**COPLEY TOWNSHIP
ARCHITECTURAL REVIEW BOARD
BELLVY NAIL SPA
STAFF REPORT**

July 5, 2022

PROJECT: Bellyv Nail Spa 3900 Medina Rd. Suite PPN: 1508295	APPLICATION TYPE: Minor Site Plan-Building Sign & Business Center Sign Panel
APPLICANT/LANDOWNER	APPLICANT: Todd Evans, Fastsigns LANDOWNER: Montrose Center LTD
COMPANY PERFORMING WORK REQUESTED	Archer Signs
INVESTMENT	\$3500
APPLICATION SUMMARY	Applicant, Todd Evans, on behalf of Bellyv Nail Spa., is requesting to place a new building sign and a panel in the Business Center Sign for the purpose of advertising the change of business name from Envy Nail to Bellyv Nail Spa.
INITIATED BY	Applicant
DECISION TYPE	<input type="checkbox"/> Informational <input type="checkbox"/> Direction <input checked="" type="checkbox"/> Action
CODE REFERENCES	Article 8-Sign Regulations, Section 8.07-Signs in Commercial and Industrial District, Table 1:

BUILDING SIGN

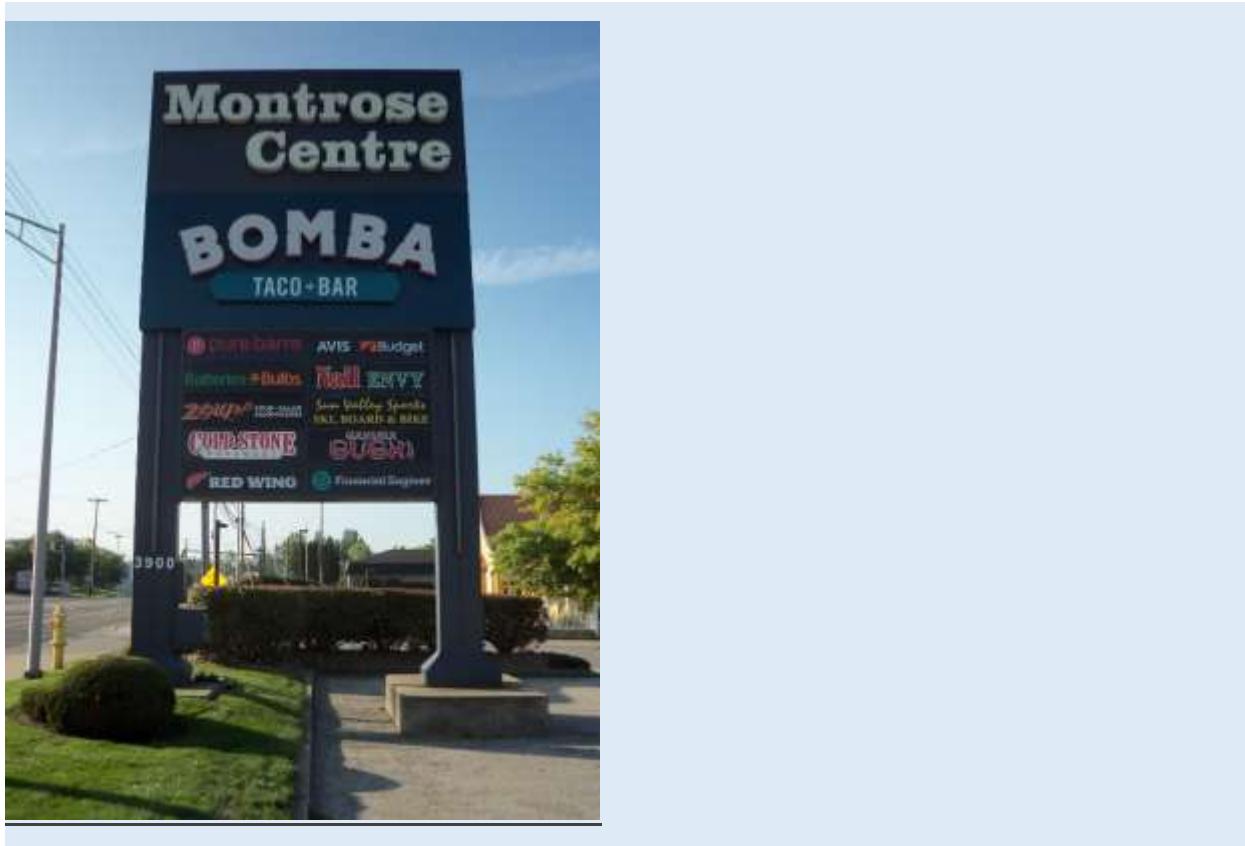
The applicant is requesting a building sign at 26.5 square feet in overall area.

The sign is comprised of channel letters with white acrylic faces placed on aluminum returns flush mounted to the wall.

- c) Is the proposed sign, or combination of signs, appropriately proportioned to the size, shape and height of the façade on which it will be displayed? **YES**

- d) Is the proposed sign or combination of signs, compatible with and complements the design of the building it identifies in terms of materials, colors and design? **YES**

- e) Does the proposed sign or combination of signs, use high-quality materials and workmanship, and/or is of a unique design that exhibits imagination and inventiveness, so as to make a positive visual contribution to the community? **The sign is compatible with other channel letter signs on this building.**

The Copley Township Architectural Review Board moves to approve the building sign as proposed at 26.5 square feet in overall area.
